Access Compliance Report

Public Rights-of-Way

(Curb Ramps)

Intersection ID: 51586	Main Street: SHAFTESBURY_RD	Cross Street: ALDEN_OAKS_DR	Location: S
ADA ID: 4A144E4A03CD	Ramp Type: Perp	Initial Pass/Fail: Fail	Overall Compliance: No
Severity Score: 12.5			
Codes/Mitigation Info/Possible Solution		Field Measurements/Component Compliance

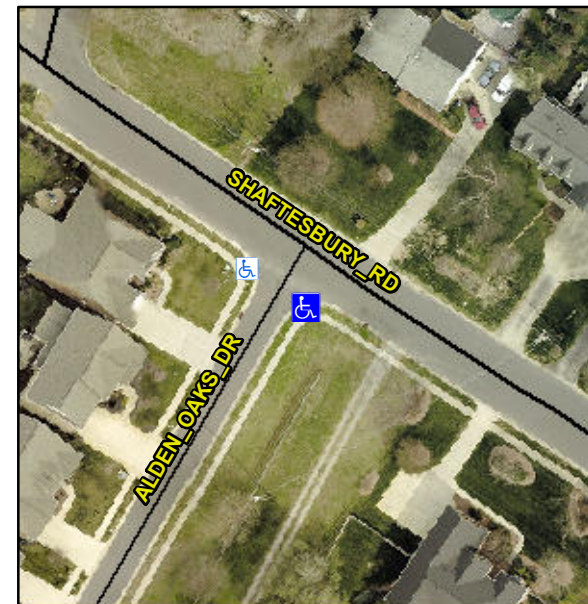
R304.5.3

Compliance	Description	Data	Compliance	Description	Data
N/A	Ramp Length (in)	48.0	Yes	Ramp Slope (%)	7.5
Yes	Ramp Width (in)	48.0	No	Ramp XSlope (%)	5.1
N/A	Flare Type LT	N/A	N/A	Flare Type RT	N/A
N/A	Flare Slope LT (%)	N/A	N/A	Flare Slope RT (%)	N/A
N/A	Flare Traversable LT?	N/A	N/A	Flare Traversable RT?	N/A
N/A	Landing Length (in)	N/A	N/A	DWS Provided?	N/A
N/A	Landing Width (in)	N/A	N/A	DWS Contrast?	N/A
N/A	Landing Slope (%)	N/A	N/A	DWS Length (in)	N/A
N/A	Landing X Slope (%)	N/A	N/A	DWS Full Width?	N/A
N/A	Landing Curb? (Y/N)	N/A	N/A	DWS Offset (in)	N/A
N/A	Shared Landing?	N/A			
N/A	Gutter Ponding?	N/A	N/A	Gutter Slope (%)	N/A
N/A	Gutter Lip Ht (in)	N/A	N/A	Gutter X Slope (%)	N/A
N/A	Painted X Walk1?	No	N/A	Painted X Walk2?	N/A
	X Walk 1 Direction	To NW		X Walk 2 Direction	N/A
N/A	X Walk 1 Width (in)	N/A	N/A	X Walk 2 Width (in)	N/A
	X Walk 1 Slope (%)	1.2		X Walk 2 Slope (%)	N/A
	X Walk 1 X Slope (%)	3.6		X Walk 2 X Slope (%)	N/A

Remove & Replace Entire Ramp.
